### **Bellenden Road – Holly Grove – Lyndhurst Way Cycling and Walking Improvements**

#### **Outline Design Layout**

#### **Response Summary**

**Full Response**

**BELLENDEN ROAD - PROPOSED LAYOUT PART 1**

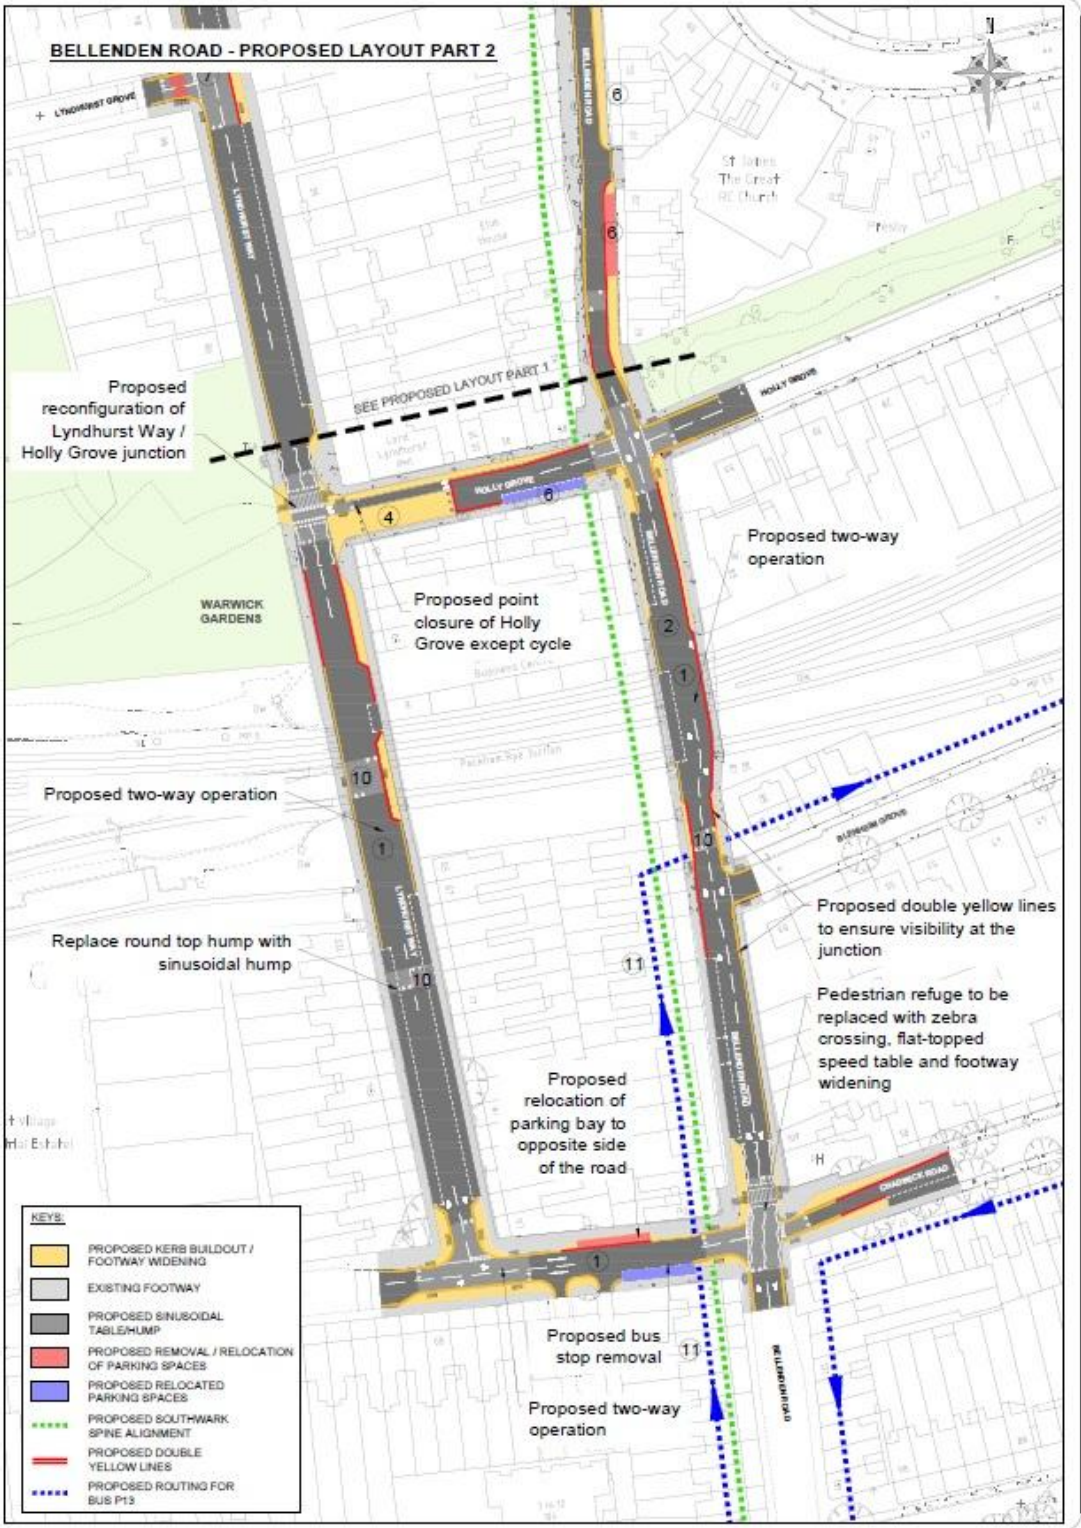
Highshore Road - scheme would expect cyclists to turn across a newly created blind corner, major rethink needed

At the junction of Bellenden and Highshore Roads, the Southwark Spine route would expect cyclists to turn right here across a blind corner with motor vehicle priority created by this scheme. There is currently a roundabout here. Southwark should consider improving the roundabout - by raising it on a table improving the public realm - or redesigning this part of the route to account for the increased cycle flows expected once the Southwark Spine has been implemented.

Given the large volumes of peak traffic on Lyndhurst Way, the right turn from Highshore Way onto Lyndhurst will be difficult for cyclists. We object to the build-out on Lyndhurst Road immediately north of its Highshore Road junction as this would prevent the very lightly used parking being reallocated to space for cycling for the next section of the Spine. This junction is best considered as part of the consultation for that section. There is scope to reduce parking on Highshore Road further as only three properties on this section do not have off-street parking.

We suggest moving the point closure on Highshore Road to the west side of the post office. This would move post office and other delivery traffic - including lorries - away from the local residential streets.

The pavements are too narrow and at points this becomes not just inconvenient but dangerous, particularly at night. I think the pavements at Point 8 on Layout Plan 1 and also at Point 10 on Layout Plan 2 are particularly narrow considering the width of the road. There is also a tree which makes pavement access very difficult at the most southerly point of Lyndhurst way.

**1. Do you support the proposed two-way operation on Lyndhurst Way, Holly Grove, Bellenden Road and Chadwick Road?**

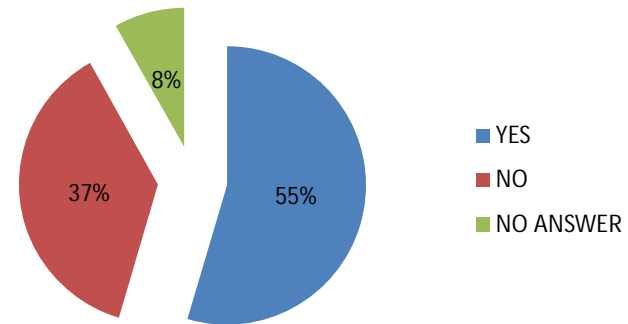
Comment	Key Considerations (and Responses)
Support of the proposal, agreeing that the current layout encourages aggressive behaviour and is considered to be unsafe to all road users, particularly cyclists and pedestrians.	N/A
Overall objection to the proposal, based on the increase in the traffic (and therefore noise, pollution, loss of the sense of community, etc) in the streets affected.	N/A
The proposal will cause increased flows and congestion on Lyndhurst Way. This will increase noise and air pollution.	Traffic flows on Lyndhurst Way will increase as a result of the road closures on Bellenden Road and Holly Grove. Existing AM and PM peak hour flows on Lyndhurst Way (between Chadwick Rd and Holly Grove) are 620 pcus and 390 pcus respectively. The proposed layout is predicted to increase the flows to approximately 850 pcus in both peak periods. Lyndhurst Way is considered to be the more suitable road to carry traffic flow in the area due to the wider road width and its alignment.

The proposal will cause increased flows and congestion on Chadwick Road.	Traffic flows on Chadwick Road will increase as a result of the road closures on Bellenden Road and Holly Grove. The proposed layout is predicted to increase the flows by approximately 290 pcus and 560 pcus in the AM and PM peak periods.
The proposal will create unsafe junctions on Chadwick Road with two way traffic and narrow road width.	The proposal will be independently safety audited as part of the formal process.

**2. Do you support the proposed 'No through' access for motorised traffic on Bellenden Road between Highshore Road and Blenheim Grove?**

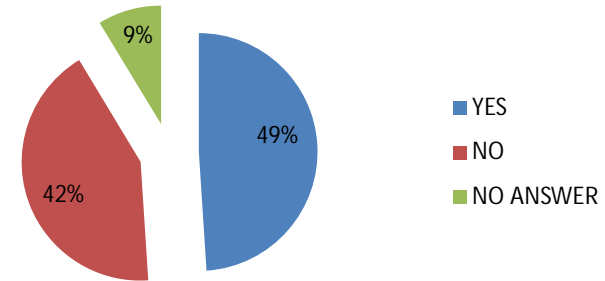
Comment	Key Considerations (and Responses)
<p>More traffic is going to be funnelled to Lyndhurst Way.</p>	<p>In order to create a quieter route for walking and cycling, through traffic on Bellenden Road has to be reduced. Traffic flows on Lyndhurst Way will increase as a result of the road closures on Bellenden Road and Holly Grove. Existing AM and PM peak hour flows on Lyndhurst Way (between Chadwick Rd and Holly Grove) are 620 pcus and 390 pcus respectively. The proposed layout is predicted to increase the flows to approximately 850 pcus in both peak periods. Lyndhurst Way is considered to be the more suitable road to carry traffic flow in the area due to the wider road width and its alignment.</p>
<p>Delivery lorries need to access the businesses on this part of Bellenden Road and may not be able to turn around to exit.</p>	<p>Road width on Bellenden Road is not proposed to change except in the vicinity of junctions. Although the road is proposed to be made two-way, deliveries vehicles will be able to access businesses on Bellenden Road.</p>

<p>The creation of potential antisocial areas on this sites due to low volume of traffic, and the fact that road closures on other places have generated social anger before.</p>	<p>Street lighting will be reviewed as part of the detailed design if the proposed scheme is to go ahead. This will likely improve the perception of safety and discourage antisocial behaviour.</p>

**3. Do you support the proposed reconfiguration of the William Griggs Garden to provide turnaround facility for Bellenden Road?**

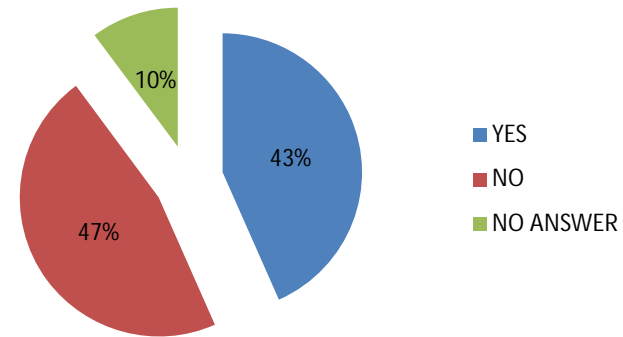
Comment	Key Considerations (and Responses)
Concerns with the turnaround facility and reconfiguration will have detrimental effect on the urban environment.	The whole garden will be redesigned to ensure impact on the environment is minimal. It is proposed to increase the size of the gardens.
This proposal appear to required the removal of two mature trees and bedding plants, reducing the green areas and therefore converting this into a less pleasant place.	The two mature trees next to No. 71 Elm Grove will be retained. Potentially one tree will be removed. However, the garden will be redesigned with minimising lost of trees in mind. Any tree removed will be replaced.
Blockage could occur in this place when large vehicles, or a high volume of traffic (there is a church and a community building in the area where events are held) using this stretch of Bellenden Road.	The existing single yellow lines will be reviewed and an assessment will be made to consider whether double yellow lines are required for this section of Bellenden Road.

**4. Do you support the proposed closure of Holly Grove by Lyndhurst Way to vehicular traffic to improve access to Warwick Gardens for pedestrians and cyclists?**

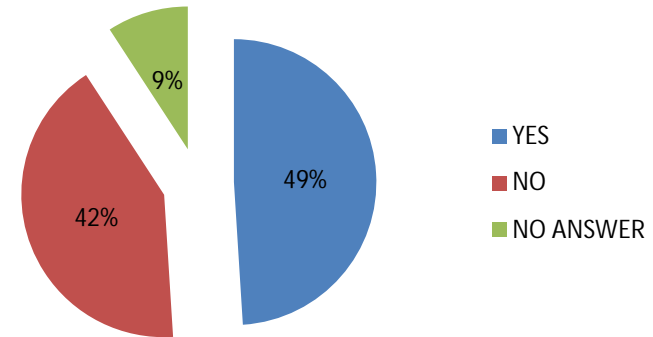
Comment	Key Considerations (and Responses)
<p>Objections to this proposal are supported by the belief that a large amount of the traffic will be diverted into Lyndhurst Way, creating congestion along this street.</p>	<p>In order to create a quieter route for walking and cycling, through traffic on Bellenden Road has to be reduced. Traffic flow will increase on Lyndhurst Way as a result of the road closures on Bellenden Road and Holly Grove. Existing AM and PM peak hour flows on Lyndhurst Way (between Chadwick Rd and Holly Grove) are 620 pcus and 390 pcus respectively. The proposed layout is predicted to increase the flows on this street to approximately 850 pcus in both peak periods. Lyndhurst Way is considered to be the more suitable road to carry traffic flow in the area due to the wider road width and its alignment.</p>
<p>Complaints about how to access to house entrances in the case of having to load/unload have been received from residents of this street.</p>	<p>Holly Grove between Bellenden Road and Lyndhurst Way can be accessed via Bellenden Road under the two-way proposal.</p>

<p>There are also concerns of the area potentially attracting antisocial behaviour due to reduced level of traffic.</p>	<p>Street lighting will be reviewed as part of the detailed design if the proposed scheme is to go ahead. This will improve the perception of safety and discourage antisocial behaviour.</p>

**5. Do you support the proposed modifications of Highshore Road/  
Bellenden Road/ Elm Grove junction to give priority to Highshore Road  
west and Bellenden Road north?**

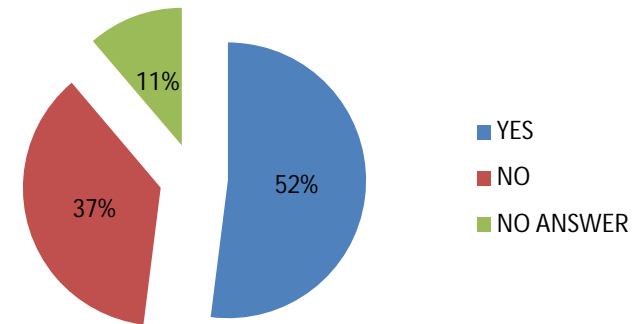
Concern about the Spine routing cyclists to turn right from Highshore Road into Bellenden Road where visibility is restricted. Also in the opposite direction where cyclists.

Raised sinusoidal humps are proposed either side of the junction to reduce vehicle speeds. Cyclists turning right into Bellenden Road will be able to take a more central position to improve their intervisibility with other road users.

**6. Do you support the proposed new footway on the eastern side of Bellenden Road between Holly Grove and Highshore, which requires relocating all existing parking bays to Holly Grove?**

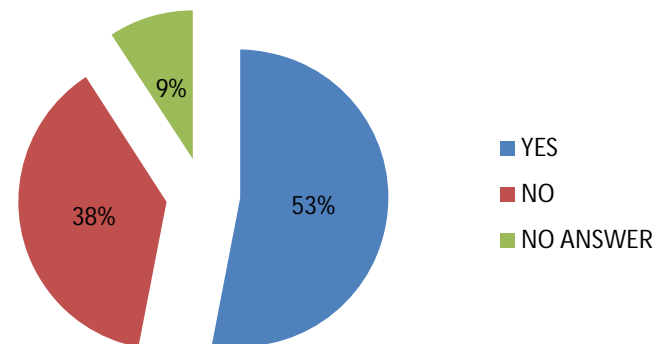
Comment	Key Considerations (and Responses)
Concerns about to the loss of residential parking bays on Bellenden Road.	The parking bays are relocated to Holly Grove, with the total number of parking bays remaining the same at this location. At present, there is no footway at this location which causes a potential safety issue where there is no buffer between the properties and live carriageway. The proposed footway will allow pedestrians who wish to stay on the eastern side of the road to do so, instead of being forced to cross the road and continue their journey on the western footway.
There are also concerns on the congestion that this street configuration could carry along, with people parking during the weekend on the single yellow line, leaving (perhaps) some resident's driveways blocked and complicating access to emergency services and other large vehicles.	The existing single yellow lines will be reviewed and an assessment will be made to consider whether double yellow lines are required for this section of Bellenden Road.

**7. Do you support the proposed 'No through' access on Bellenden Road by William Griggs Garden to vehicular traffic?**

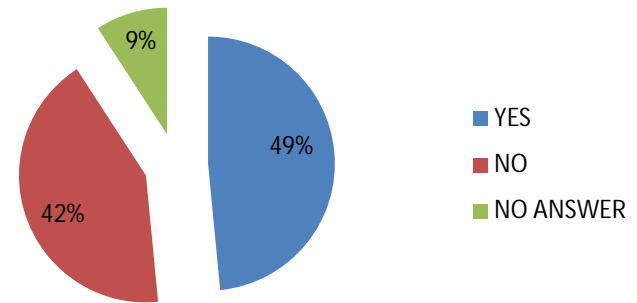
Comment	Key Considerations (and Responses)
<p>More traffic is going to be funnelled to Lyndhurst Way.</p>	<p>In order to create a quieter route for walking and cycling, through traffic on Bellenden Road has to be reduced. Traffic flow on Lyndhurst Way will increase as a result of the road closures on Bellenden Road and Holly Grove. Existing AM and PM peak hour flows on Lyndhurst Way (between Chadwick Rd and Holly Grove) are 620 pcus and 390 pcus respectively. The proposed layout is predicted to increase the flows to approximately 850 pcus in both peak periods. Lyndhurst Way is considered to be the more suitable road to carry traffic flow in the area due to the wider road width and its alignment.</p>
<p>Delivery lorries need to access the businesses on this part of Bellenden Road and may not be able to turn around to exit.</p>	<p>Road width on Bellenden Road is not proposed to change except in the vicinity of junctions. Although road is proposed to be made two-way, deliveries vehicles will be able to access businesses on Bellenden Road.</p>

<p>The creation of potential antisocial areas on this sites due to low volume of traffic, and the fact that road closures on other places have generated social anger before.</p>	<p>Street lighting will be reviewed as part of the detailed design if the proposed scheme is to go ahead. This will improve the perception of safety and discourage antisocial behaviour.</p>

**8. Do you support the proposed two-way operation of Highshore Road and the removal of 10 parking spaces?**

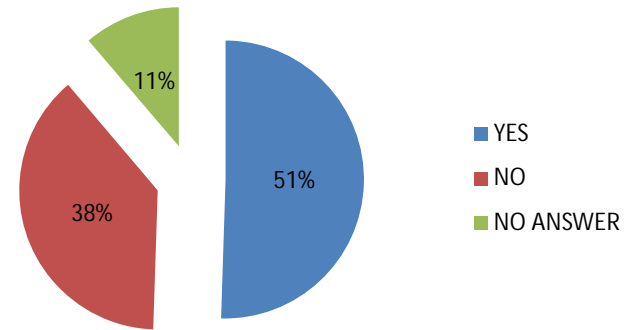
Comment	Key Considerations (and Responses)
<p>Concern with the loss of parking bays in an area which is already difficult to find spaces. In the future, this is believed to be aggravated by the 60-flat development that is being built on this street. Concern the problem of losing parking space in front of a veterinary clinic situated in 35 Highshore Rd, as walking the distance from the closest parking bay into the clinic carrying an injured animal might not be feasible.</p>	<p>Observations of parking use at this location suggested that demand at these parking bays is low. However, Officers will review the design and investigate the possibility of retaining some parking bays on the northern side of Highshore Road.</p>
<p>There are concerns about the consequences of the 2-way system on Highshore Rd, which would increase the flows on Bellenden (northbound) thus creating congestion.</p>	<p>Traffic flows on Bellenden Road north of Highshore Road are not expected to be increased by the scheme. Currently, motor vehicles can access that section via Bellenden Road south of Highshore Road. Vehicles wishing to access that part of Bellenden Road from south of Highshore Road will simply be reassigned to Lyndhurst Way and then Highshore Road.</p>

**9. Do you support the proposed footway widening and raised table at junctions to reduce crossing distances and improve accessibility? This involves removing 4 parking spaces on Lyndhurst way by Lyndhurst Grove.**

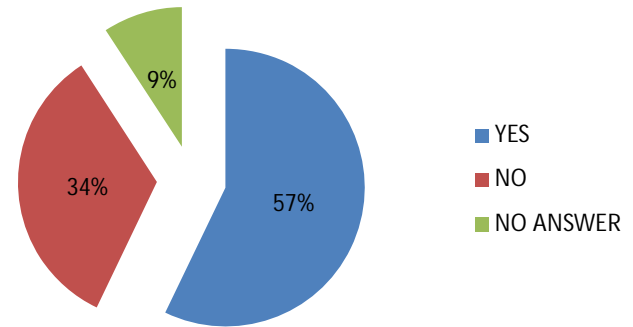
Comment	Key Considerations (and Responses)
<ul style="list-style-type: none"> <li>Bellenden Rd/Chadwick Rd junction:</li> </ul> <p>The 2-way system along Chadwick Road will make this narrow junction congested and dangerous. Currently priorities are unclear and need clearer signage. The council should look into signalisation the junction.</p>	<p>The carriageway width is sufficient for two-way traffic. The new junction layout will provide clear priority for Bellenden Road north-south traffic. Chadwick Road traffic will have to give-way, signage will be provided to ensure that priority is clear for all traffic. Signalisation is not considered at present as the area is mainly residential and traffic signals would potentially result in queuing vehicles outside of the typical peak periods. The proposal is currently undergoing road safety audit, if there is a safety concern at the junction, signalisation or other measures will be analysed.</p>

<ul style="list-style-type: none"> <li>Lyndhurst Way/Chadwick Rd junction:</li> </ul> <p>This junction will be congested with the new layout and increased level of traffic, making it dangerous for all users and probably not allowing large vehicles to turn without conflict.</p>	<p>Sweptpath analysis had been carried out and will be reviewed again during detailed design to ensure vehicles can manoeuvre safely. As most vehicles will be right turning from Chadwick Road into Lyndhurst Way or left turning from Lyndhurst Way into Chadwick Road, the main movements are not in conflict and thus congestion is not expected at this location.</p>

**10. Do you support the proposed replacement of existing traffic humps with sinusoidal humps?**

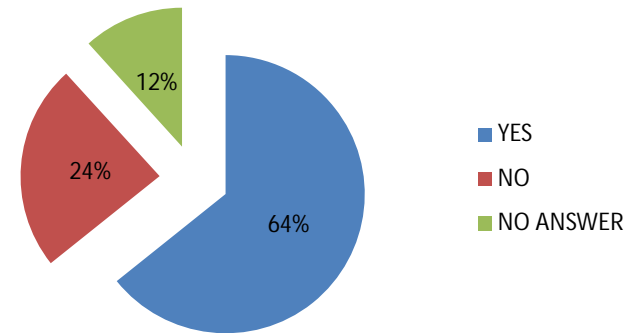
Comment	Key Considerations (and Responses)
Most comments are supportive on the installation of speed humps (of any kind).	N/A
At least three of the responses referred to the fact that humps were damaging their properties, specially when larger vehicles drove over them.	Sinusoidal profile humps proposed has benefit in giving less discomfort to cyclists and motorists travelling at low speed. Research has shown speed reductions are likely to be similar to round-top humps. Maximum noise and ground-bourne vibration levels generated are likely to be less than for round-top humps.
Comments on sinusoidal humps have been proven to encourage a more aggressive behaviour from the motorised vehicles.	Research has shown speed reductions are likely to be similar to round-top humps.

**11. Do you support the proposed routing of the bus P13 to turn right directly into Belnheim Grove?**

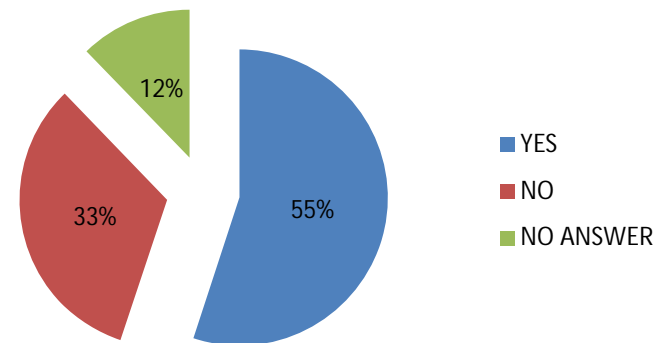
Comment	Key Considerations (and Responses)
<p>There were concerns about bus stop stays being removed from Chadwick Road as it is more convenient for some residents at present. Not everyone's mobility allows them to make an extra displacement to reach the new bus stop.</p>	<p>Under the new layout, buses will not be able to remain on its existing route through the gyratory. Officers will liaise with TfL buses to investigate possible alternative locations for the bus stop.</p>

**12. Do you support the double yellow lines to improve visibility/ safety for all road users?**

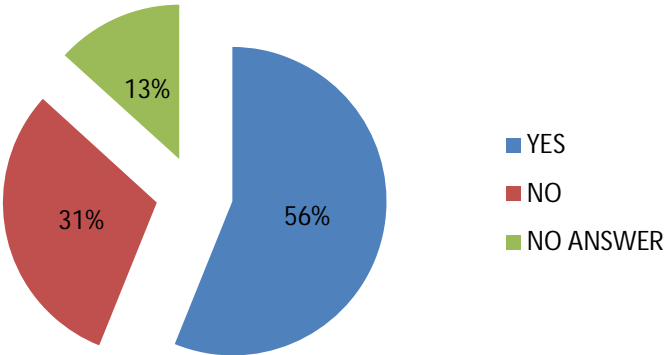
Comment	Key Considerations (and Responses)
<p>Opposition to this proposal comes mainly from residents who do not find this necessary taking into account the parking loss and the damage to business that this can entail.</p>	<p>Overall, it is important that the roads are safe for all road users at all times and therefore it is important that the single yellow line restrictions are upgraded at certain locations, to maintain road user intervisibility.</p>
